**Report: TAB Report**  
**Function: Test, Adjust, & Balance**  
**Date: 12/05/2025**  
**Completed By: National TAB**

**11-03-25 WAWA #7618 LOUISVILLE, KY**

5229 DIXIE HWY

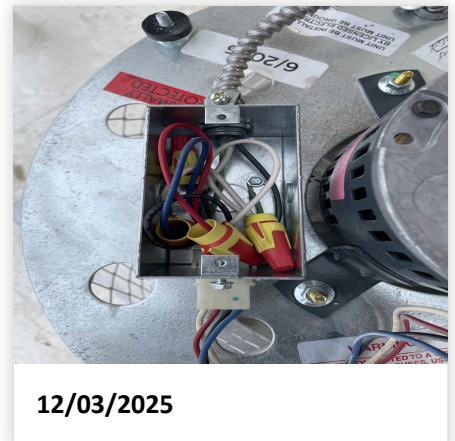
**Issue Name :** EF Speed Controller  
**Description :** Neither EF-1 nor EF-2 is equipped with a speed controller as specified in EF schedule. Unable to adjust fan speeds.  
**Created By :** National TAB      **Assigned To :** National TAB - Jordan Best  
**Status :** Open  
**Priority :** High      **Asset Tag :**  
**Originated Date :** 12/03/2025 - Jordan Best - National TAB

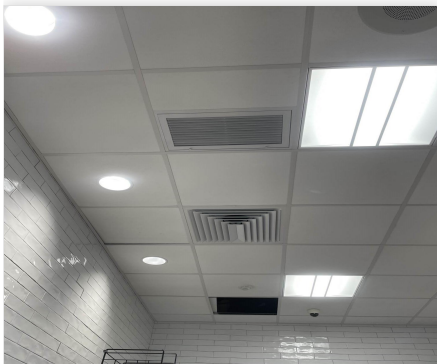
**Issue Name :** EF-2 Return 2  
**Description :** RTU-2, return 2 is oriented incorrectly. Should be flush with wall above oven.  
**Created By :** National TAB                      **Assigned To :** National TAB - Jordan Best  
**Status :** Open  
**Priority :** Medium                                      **Asset Tag :**  
**Originated Date :** 12/05/2025 - Jordan Best - National TAB

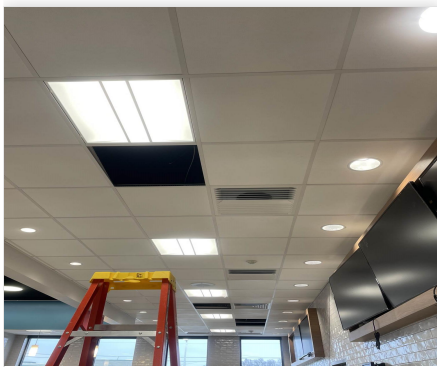
**Issue Name :** RTU-1 Cooling  
**Description :** RTU-1 discharge temp did not fall below 65 F when in full cool with both compressors on. Other units measured around 40 F.  
**Created By :** National TAB                      **Assigned To :** National TAB - Jordan Best  
**Status :** Open  
**Priority :** [Medium](#)                                      **Asset Tag :**  
**Originated Date :** 12/05/2025 - Jordan Best - National TAB
